Service Bulletin

SEB99-5

WING FUEL TANK VENT CHECK VALVE INSPECTION

Figure 1. Fuel Vent Check Valve Inspection (Sheet 1 of 1)

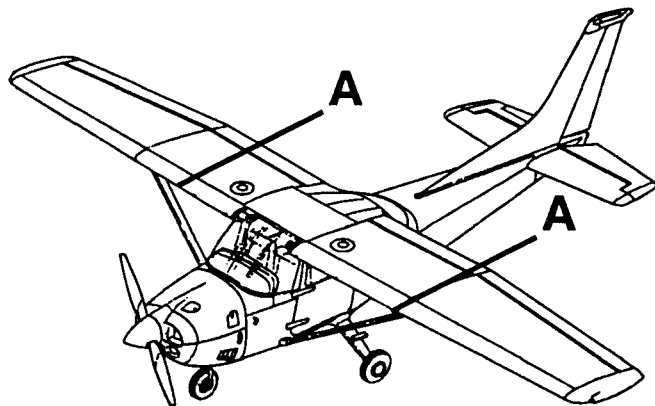
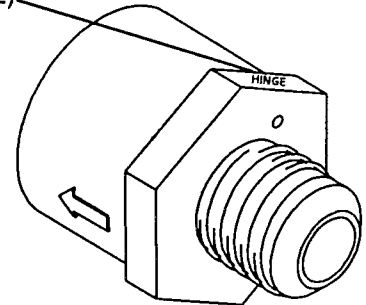
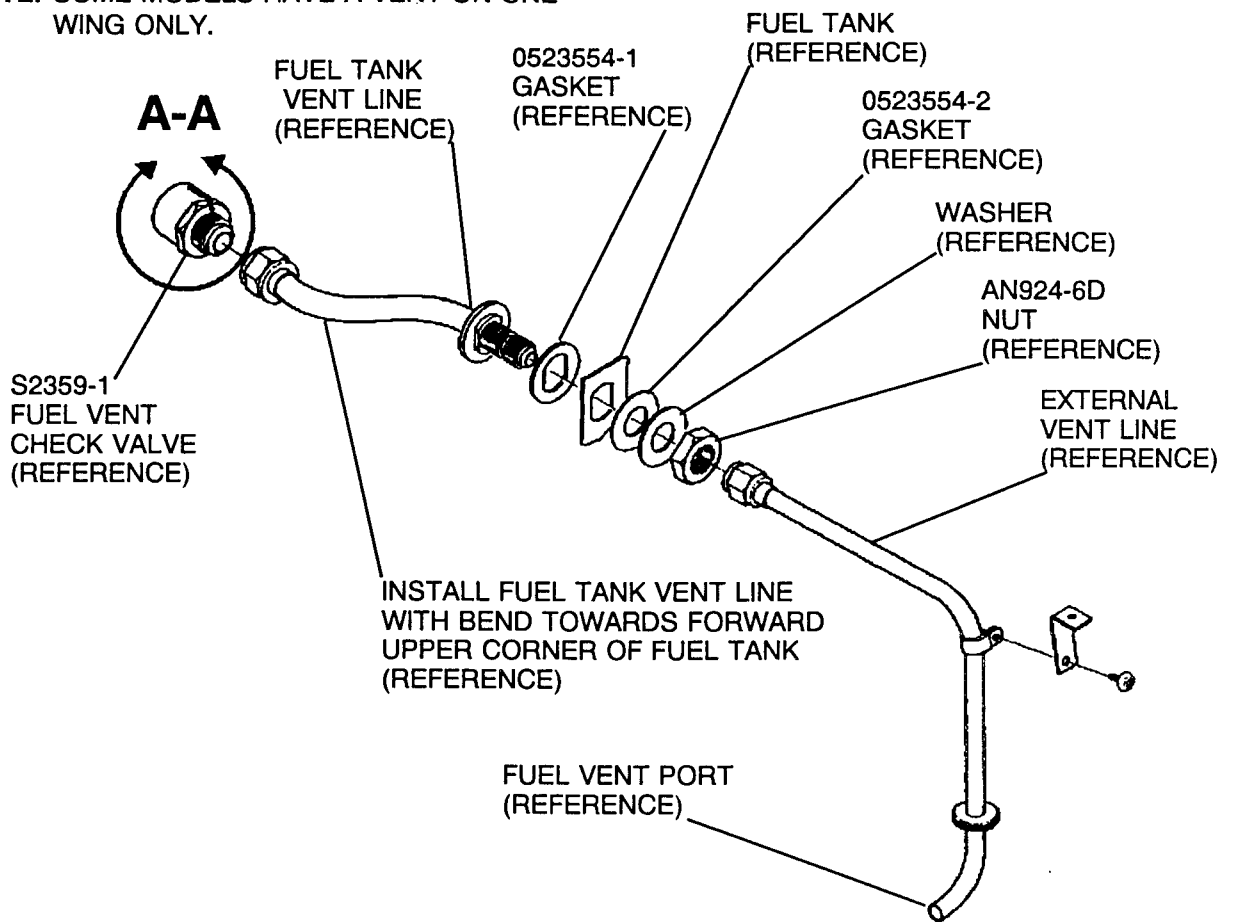
3. (Refer to Figure 1.) Locate the applicable wing fuel vent port of the affected S2359-1 Fuel Vent Check Valve.

- G. Drain fuel from wing fuel tank and gain access to the S2359-1 Fuel Vent Check Valve. Remove and replace the S2359-1 Fuel Vent Check Valve.
- (1) The following procedures applies to airplanes equipped with metal fuel tanks. Refer to Figure 1., gain access to the top of the fuel tank. Disconnect the external vent line from the fuel tank vent line.

- (3) Remove fuel tank vent line and gasket, discard gasket, and pull safety wire through fuel tank and secure end of safety wire.
- (4) Replace S2359-1 Fuel Vent Check Valve and install on fuel tank vent line as shown in Figure 1.

- (5) Using the safety wire, pull new 0523554-1 gasket, fuel tank vent line and check valve through fuel tank and position as shown in Figure 1.

INSTALL CHECK VALVE WITH "HINGE" FACING TOP OF FUEL TANK (REFERENCE)
